Docket No. 52-048

**SUBJECT:** NuScale Power, LLC Supplemental Response to NRC Request for Additional Information No. 185 (eRAI No. 8963) on the NuScale Design Certification Application

NuScale Supplemental Response to NRC Request for Additional Information eRAI No. 8963

Figure 3.8.5-1: SAP2000 Model for Evaluation of Design Forces in ~~Basemat~~the Reactor Building Basemat Model

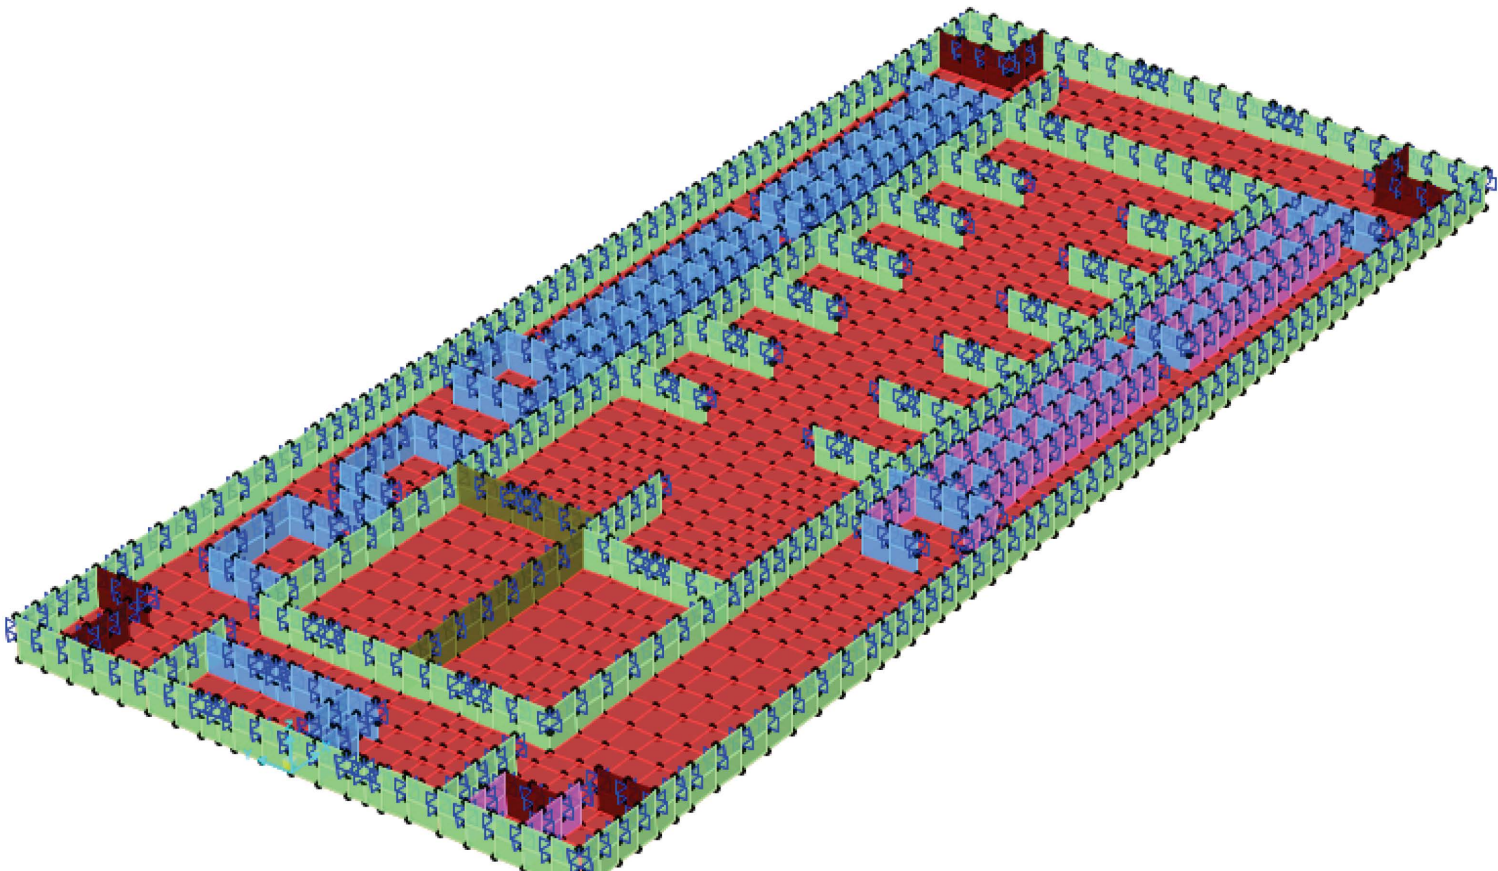
FSAR Tier 2, 3.8.5.4.1.2 (Page 3.8-58), *"RXB Basemat Analysis Model Description,"* states *"The SAP2000 model was created modeling the RXB basemat with solid elements in order to calculate forces and moments in the basemat."* Contrary to that statement, page 3.8-59 states *"Figure 3.8.5-1 shows the SAP2000 model. The area elements shown in light red tinge are shell elements representing the base slab."* Address this inconsistency. State what type of elements (solid or shell) were used in the SASSI 2010 model to calculate forces and moments in the basemat.

A supplement to NuScale's original response to RAI 8963 Question 03.08.05-11, as discussed in a public meeting on January 30, 2018, is provided to include, "RXB Basemat Model" in the titles of Figures 3.8.5-1 through 3.8.5-7.

FSAR Tier 2, Figures 3.8.5-1 through 3.8.5-7 have been revised as described in the response above and as shown in the markup provided in this response.
